TITEL: Installation av bränslepump och bränslepumpdrivning.

GÄLLER: Franklin motorer 6A-350-... och 4A-235-... utrustade med "diaphragm fuel pump" installerade eller levererade av WSK PZL Rzeszow.

Subject: Issuance of the Airworthiness Directive

NUMBER: PZL-F/72A/2002

1. PROCEDURES FOR REMOVAL OF FUEL PUMP, FUEL PUMP DRIVE, OIL HOSE, (Fig. 1).

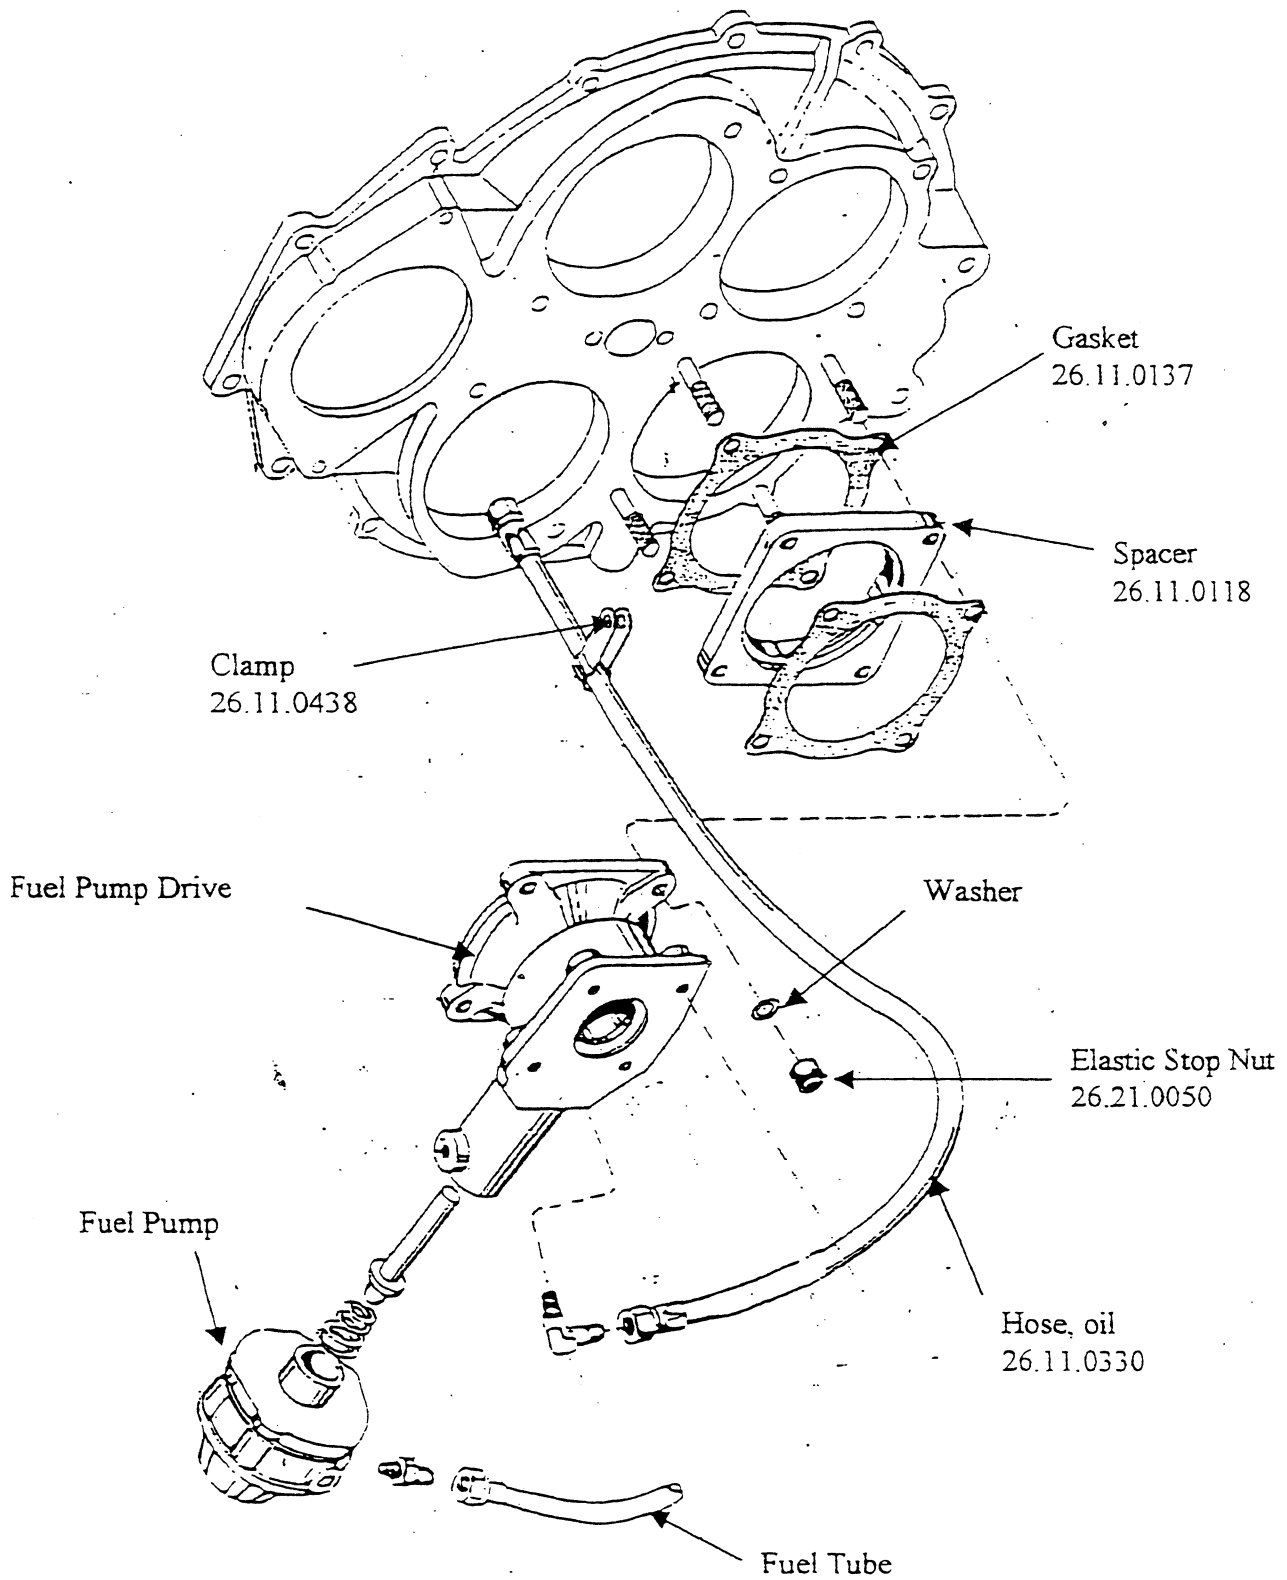
- a. Switch the pump fuel inlet to the off position;
- b. Remove all items that make it difficult to access the pump;
- c. Tag the inlet and outlet lines appropriately to avoid improper attachment during assembly. Disassemble fuel inlet/outlet lines from the pump.
- d. Unscrew both sides of 26.11.0330 Hose that supplies oil to pump drive, and 26.11.0438 Clamp.
- e. Undo four 26.21.0050 ¼"-28" Elastic Stop Nuts.
- f. Remove the "fuel pump drive" and "fuel pump".
- g. Remove 26.11.0118 Spacer, clean flange surface and its mating surface on drive cover from residuals of 26.11.0137 Gasket.
- h. 26.21.0168 Elbow is located at By-pass valve. Because the oil line that lubricate the plunger pump drive is now removed, plug the unused attachment opening by the 26.11.8330 "Cup nut" (included in replacement set).

2. PROCEDURES FOR INSTALLATION OF FUEL PUMP AND FUEL PUMP DRIVE, (Fig. 2)

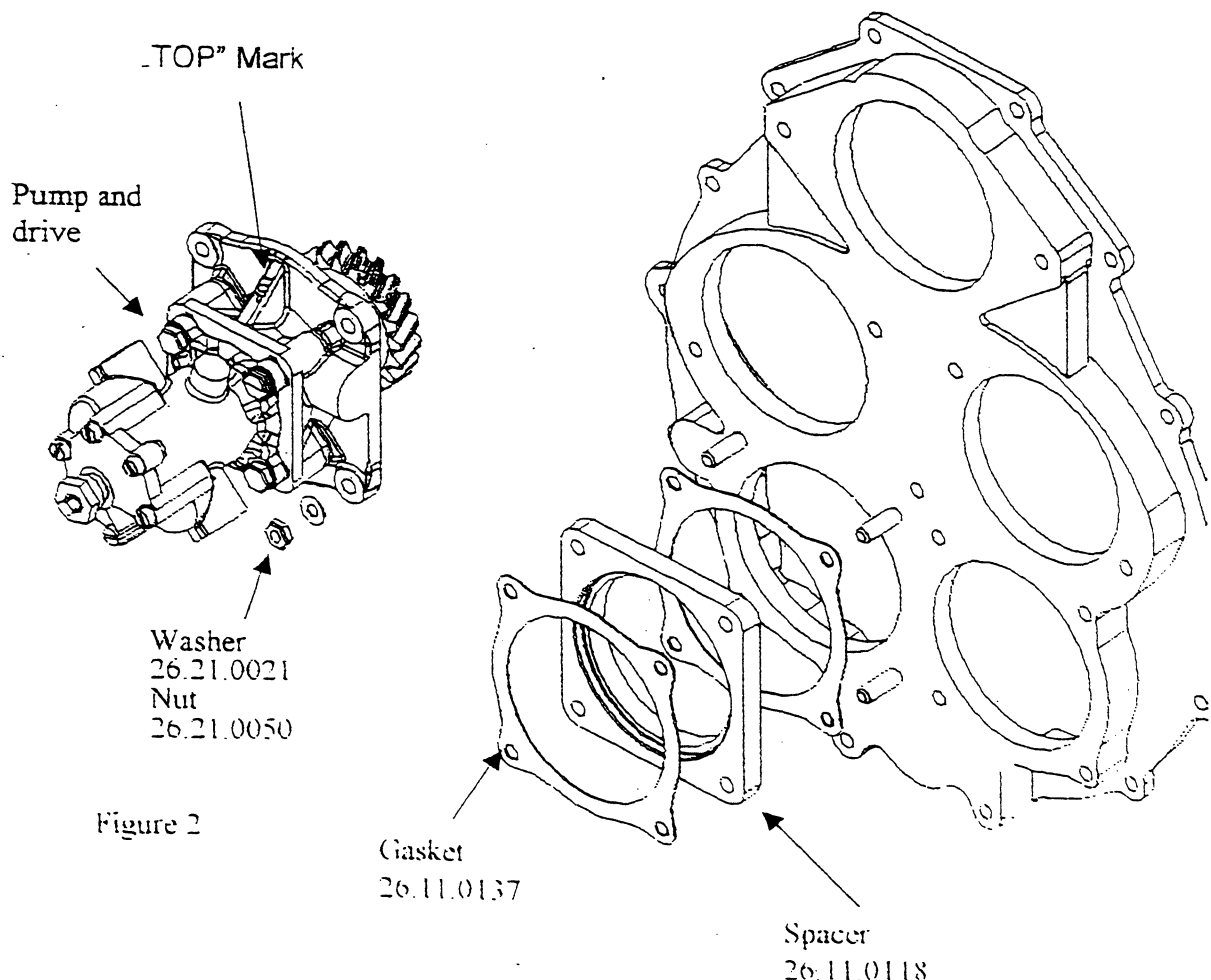
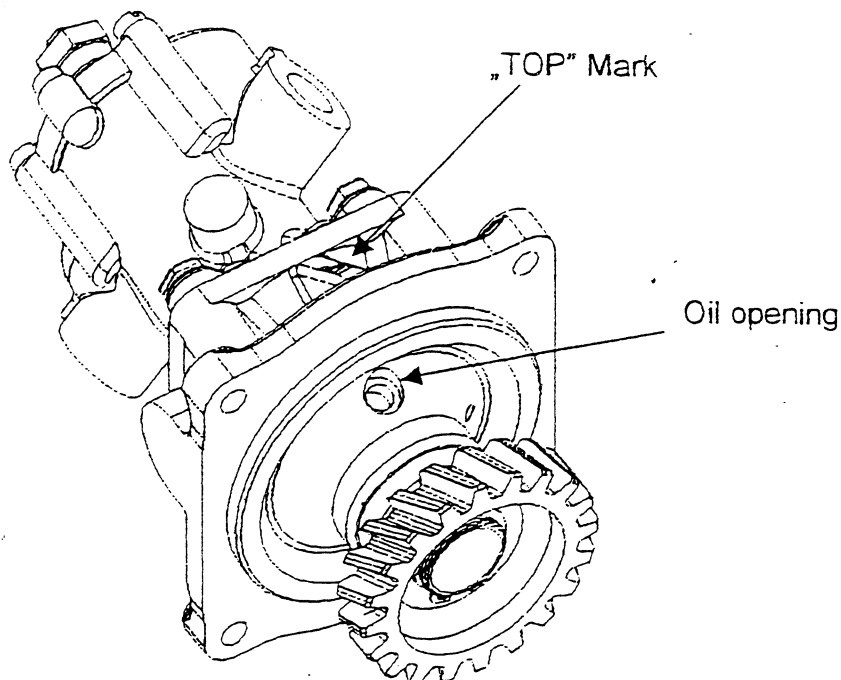
- i. Apply an aviation grade sealing compound (e.g. „Hylomar Aerograde”) on both sides of 26.11.0137 Gasket.
- j. Place 26.11.0137 Gasket, 26.11.0118 Spacer, and 26.11.0137 Gasket on the engine.
- k. Install replacement Pump Drive and Fuel Pump on the engine.

NOTE: Make sure that the rib marked "TOP" is installed in the upward position (see figure #2). With this installation arrangement, the oil opening is positioned vertically.

- l. Install four 26.21.0021 Washers and four 26.21.0050 1/4"-28" Elastic Stop Nuts, torque to 0.69-0.97 kGm (5-7 Ft lbs).
- m. Remove the shipping cups from the fuel inlet, outlet, drainage locations. Assemble the fuel inlet/outlet attachments into their appropriate openings of the fuel pump and drainage lines (see Fig. on page 7.7) as recommended by airframe manufacturer for installation of PLL-7 Pump. This can be done before installation of the pump on engine.
- n. Connect airframe fuel and drainage lines.
- o. Run the engine on ground. Check visually the fuel pump, and fuel and oil connections that were replaced during the above procedure. Pay attention for possible leak of fuel and oil.
